Product Change Notification

1. ECR #: 211640
Notification #: 622

- QFSS - .635mm DOUBLE ROW SHIELDED TERMINAL STRIP
- QFS - QFS .635mm STRIPS

4. Part #'s Affected

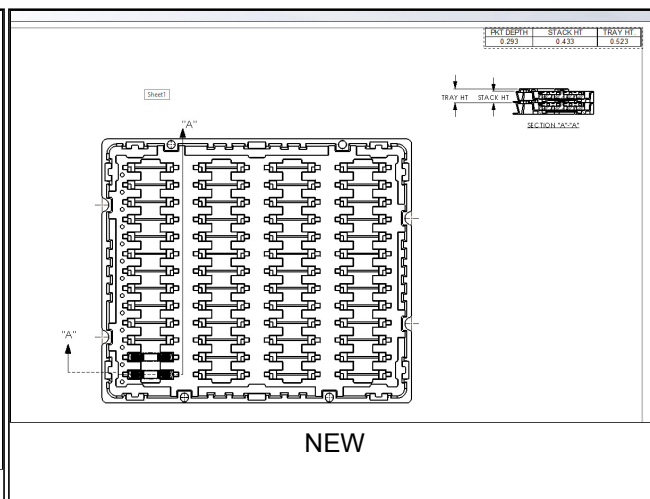
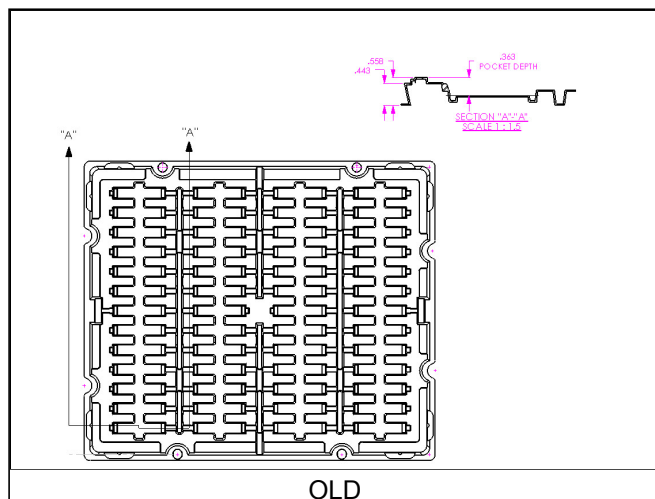
Update tray to the current design standard which means changes to pocket depth, tray height, and stack height.

Pocket depth change from 0.363" to 0.293" ; tray height change from 0.558" to 0.533" ; stack height change from 0.443" to 0.433"

The current design standard and resulting changes allow the tray to hold the part more securely and with greater stability.
